Product / Process Change Notification (PCN)

PCN #: PCN_UtRJ45LAN_20230811

Affected Series: WE-UtRJ45LAN-Series: 7498xxx

Before Change	After Change

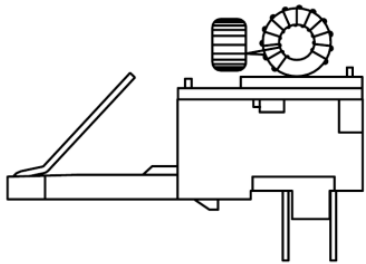
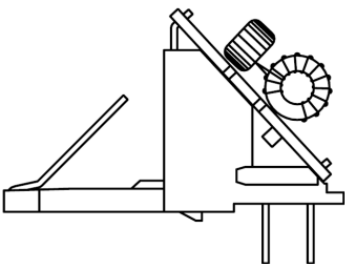
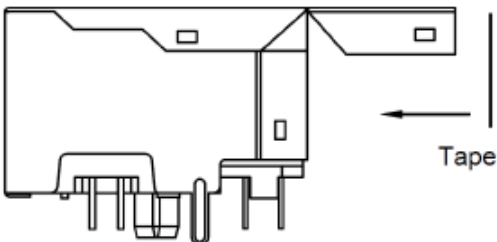
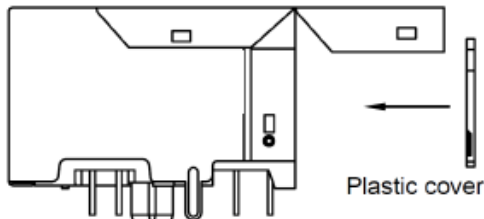
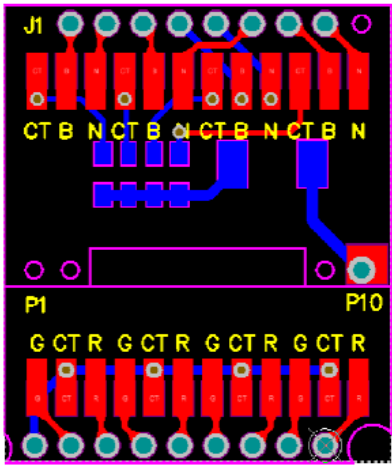
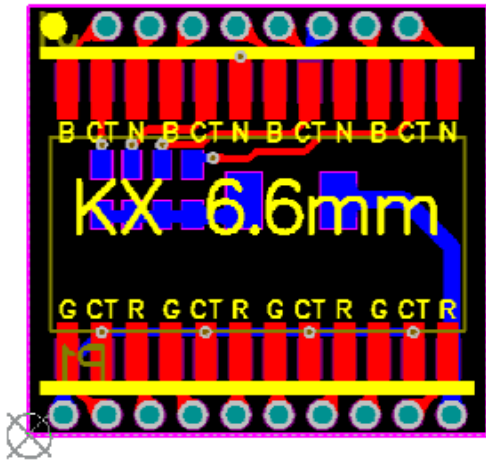
Above: Improved positioning of the PCB

Above: Improve internal insulation with change from tape to plastic cover

Above: Change in PCB layout to enhance product standardization

74980104400:

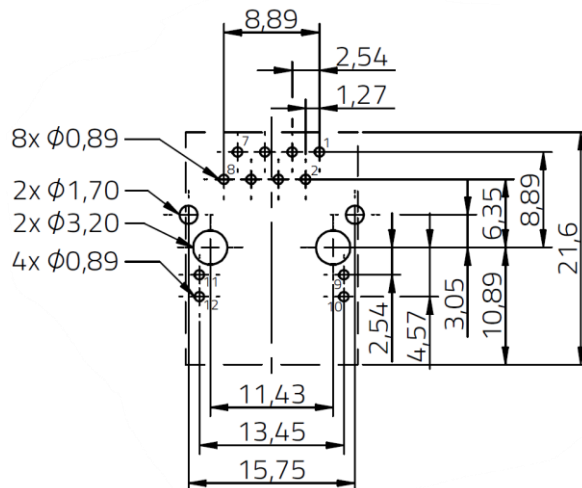
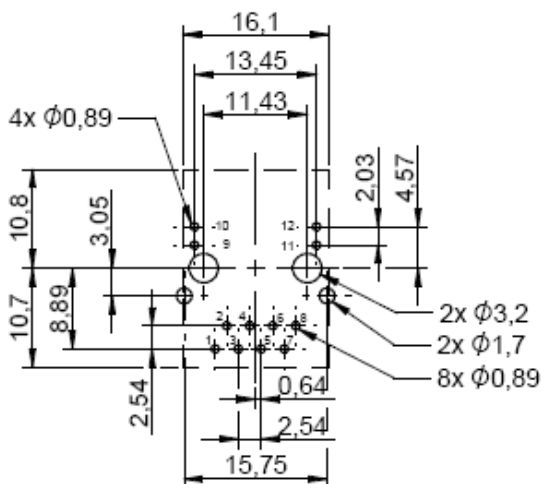
Before correction

After correction

74981100000:

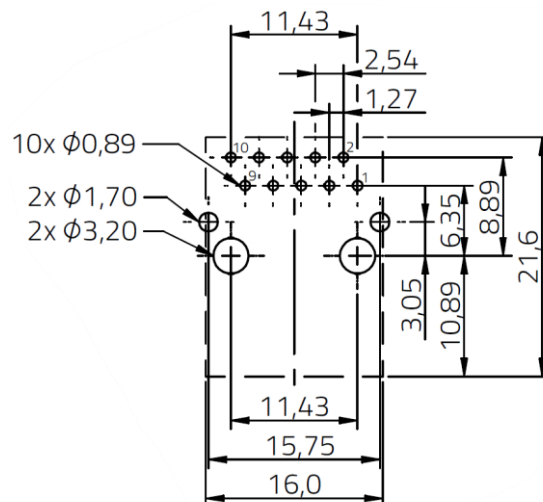
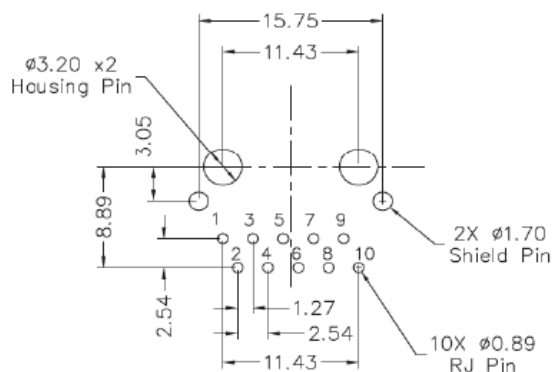
Before correction

After correction

74981104400:

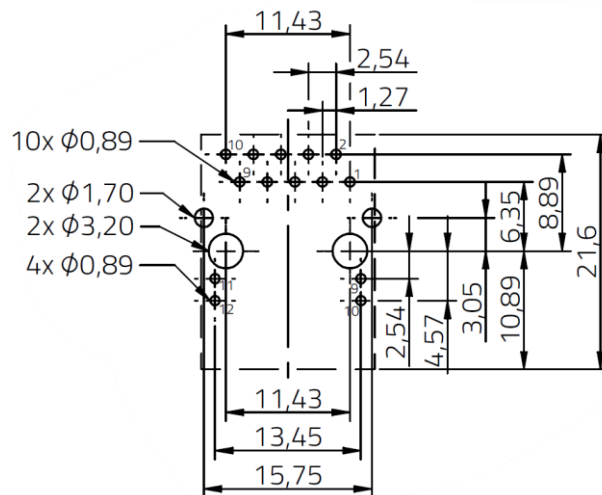
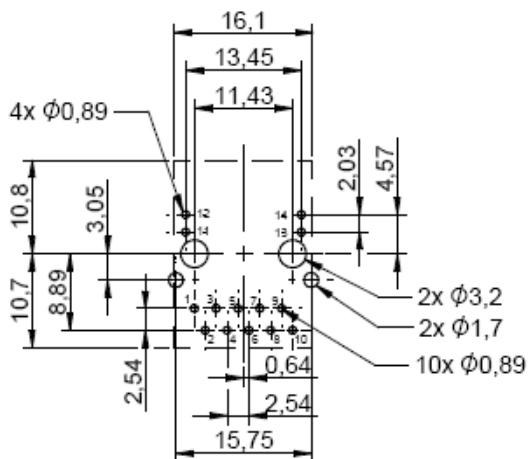
Before correction

After correction

74982104400:

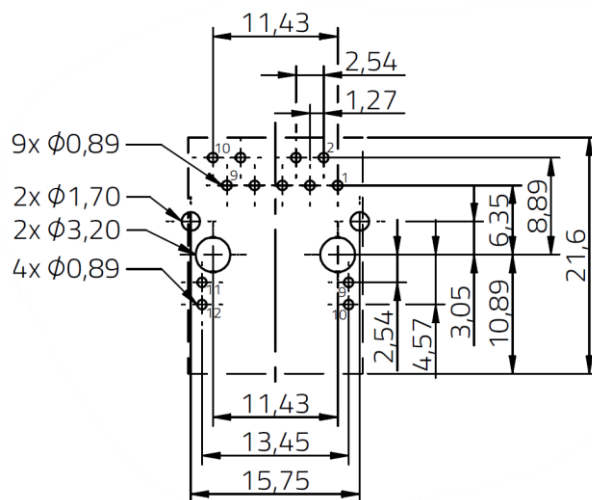
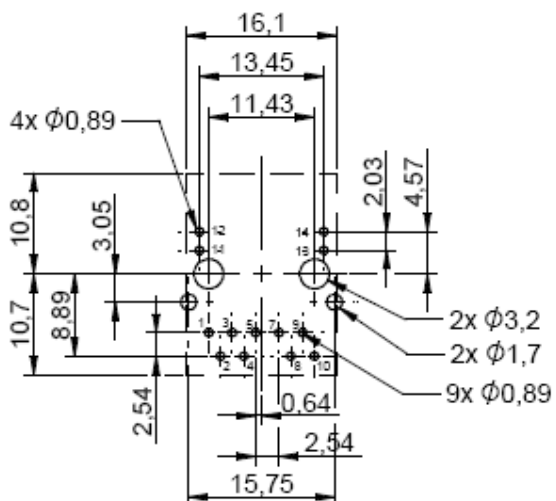
Before correction

After correction

74984104400:

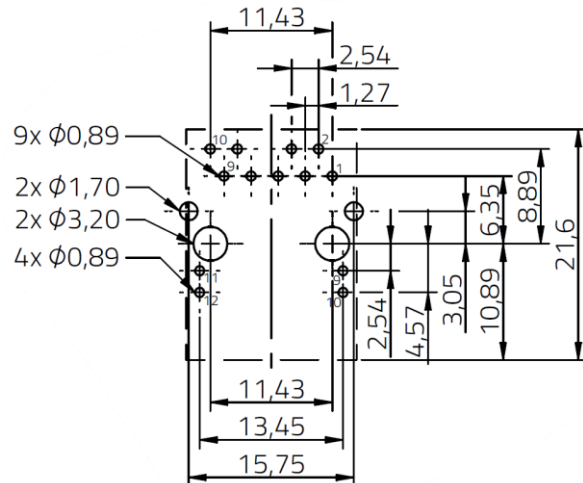
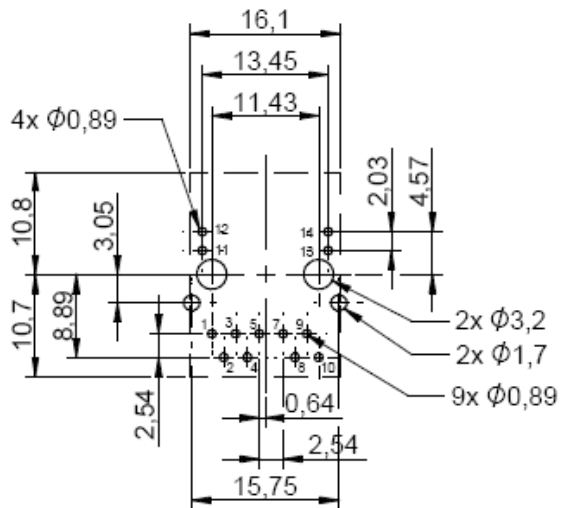
Before correction

After correction
